## 1 Reviewer 1

In the manuscript "Influence of snow surface processes on soil moisture dynamics and streamflow generation in alpine catchments", the authors present a comprehensive modeling study using the model Alpine3D which was complemented with new descriptions for simulating soil moisture and streamflow. The distributed model was forced using meteorological station data at several points and validated by means of snow depth, soil moisture, and runoff measurements.

Figure 1: Measured and simulated soil moisture at the IRKIS station SLF2, for 10 cm depth (a, c) and 30 cm depth (b, d), during the snow melt season (a, b) and a snow-free summer month (c, d). In (a) simulated snow depth and in (c) precipitation is shown.

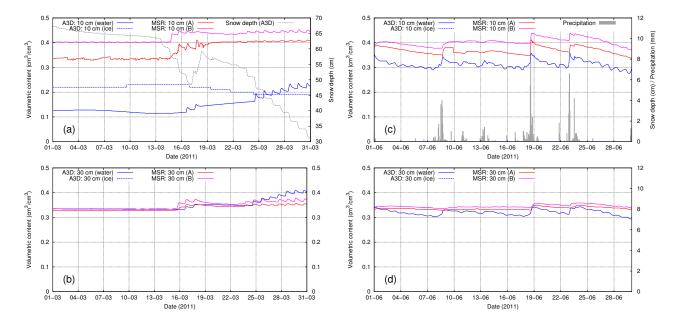
- P. 7 L. 11: Remove "also". Will be corrected, thank you.
- P. 7 L. 12: Why didn't you additionally inspect hourly values if you have the respective measurements? You could add at least some examples for showing the model performance on a smaller, hourly timescale, which would be very interesting to see.

We agree with the reviewer that it is interesting to see the hourly behaviour of the soil moisture measurements and simulations. We therefore plan to amend the manuscript with an additional figure showing for one station an example of hourly soil moisture, during both the melt season as well as the summer season (see Fig. 1).
